To: Planning Commission

Subject: Variance Condition Revision – 5800 Stuart Avenue

The Planning Commission is asked to re-consider the condition that was put on their approved Variance that required a pervious driveway. (See applicant request on pages A2-A4.) The applicant is proposing a rain garden in place of the pervious driveway, which was required as a condition of approval of the variance by the Planning Commission. (See page A1.)

Urbanski proposed landscaping - 5800 Stuart Avenue

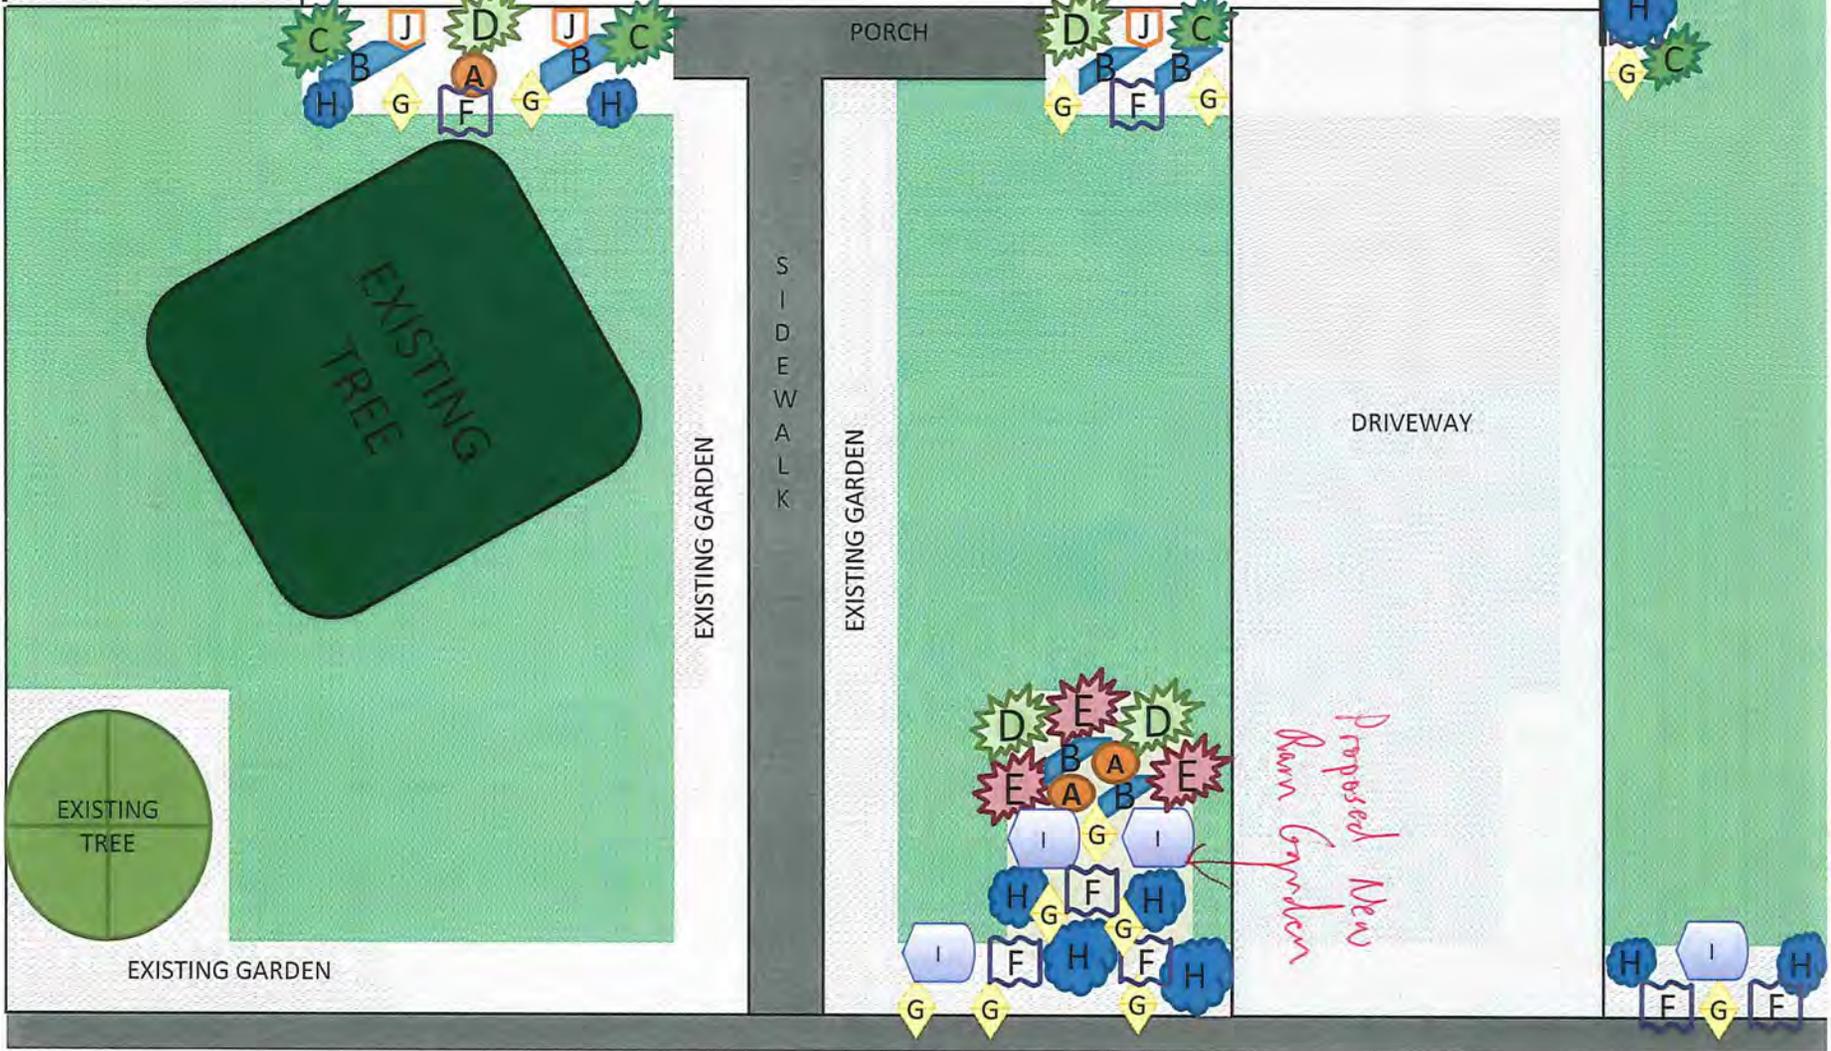
All gardens but rain garden to include wood mulch. Rain garden to include rock.

STORM WATER MANAGEMENT PLAN
C1.0

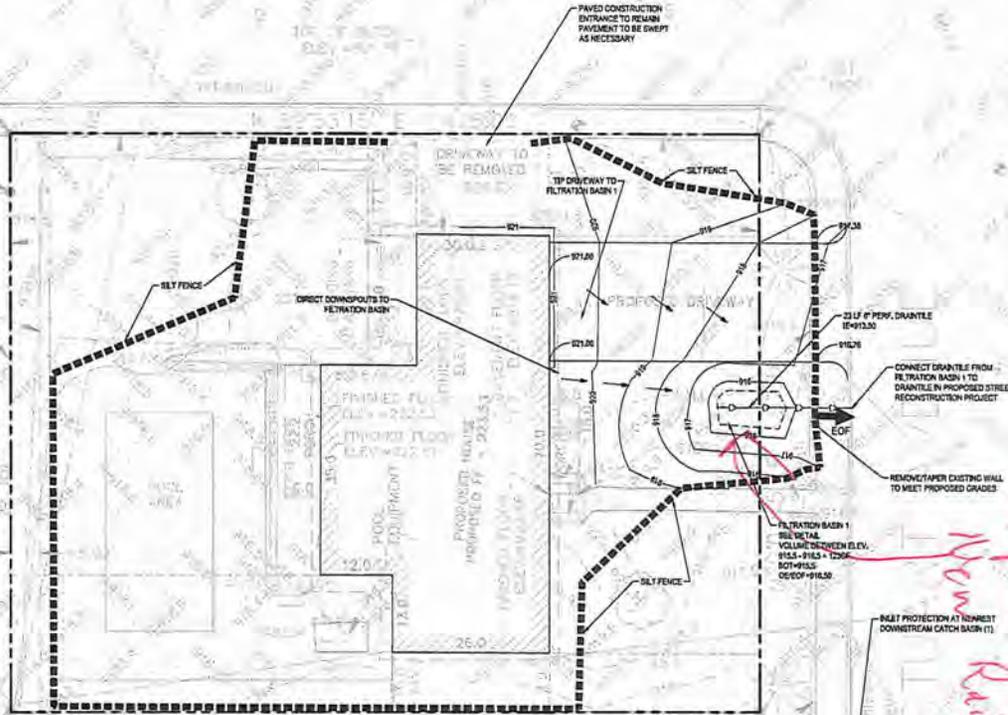
Implementing a rain garden would actually lower the storm water rate to 1.31 due to the capability of the native plants within the garden to uptake and store water slowly releasing it into the surrounding planting medium and has the added benefit of the plants ability to clean water of nutrients, pesticides and fertilizers before releasing into the surrounding soil. (Diagram 2) Although there is upkeep of a garden it would not be required on a daily basis and would only add a small amount of time to the upkeep already performed on our existing gardens. We believe that this would be a much better solution and would comply with the Environmental Engineer's memo dated August 1, 2014.

You may be better served constructing a rain garden to capture the runoff from your driveway. You

would have to do soil correction or amendments in the rain garden, but it will be more effective than pavers on clay.

The applicant has now proposed a rain garden in place of a pervious paver driveway, as conditioned by the planning commission. The rain garden proposed has been designed by a licensed engineering and satisfies the storm water constraints that our August 1, 2014 memo outlined.
